Board Staff Interrogatories 2012 IRM3 Electricity Distribution Rates West Coast Huron Energy Inc. EB-2011-0203

Rate Generator

16) Ref: E1/T2/S2 p. 8 – Calculation of Revenue Requirement

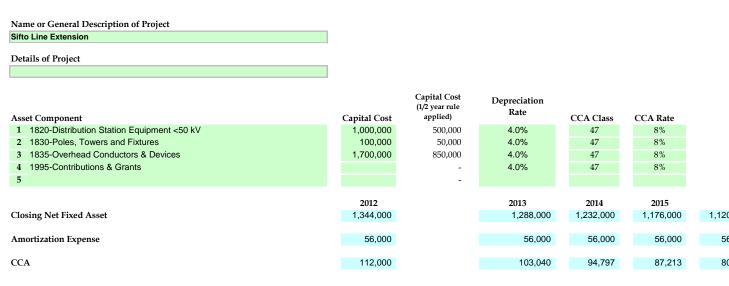
On p. 8, I. 11-12 WCH states that "the Sifto Line Extension will be approximately \$2.8M. WCH further states that the customer has not committed to contribute any monies to the development of this project. West Coast Huron intends to pursue a contribution in aid of construction consistent with the applicable requirements and will advise the Board of any developments as may develop. "

- a) Please provide WCH's current capital contribution policy.
- b) Please explain how this policy has been applied to this project.
- c) If not, please explain why not.
- d) Please provide any updates at to the status of capital contributions. Please detail any conversation/negotiations with Sifto regarding capital contributions.
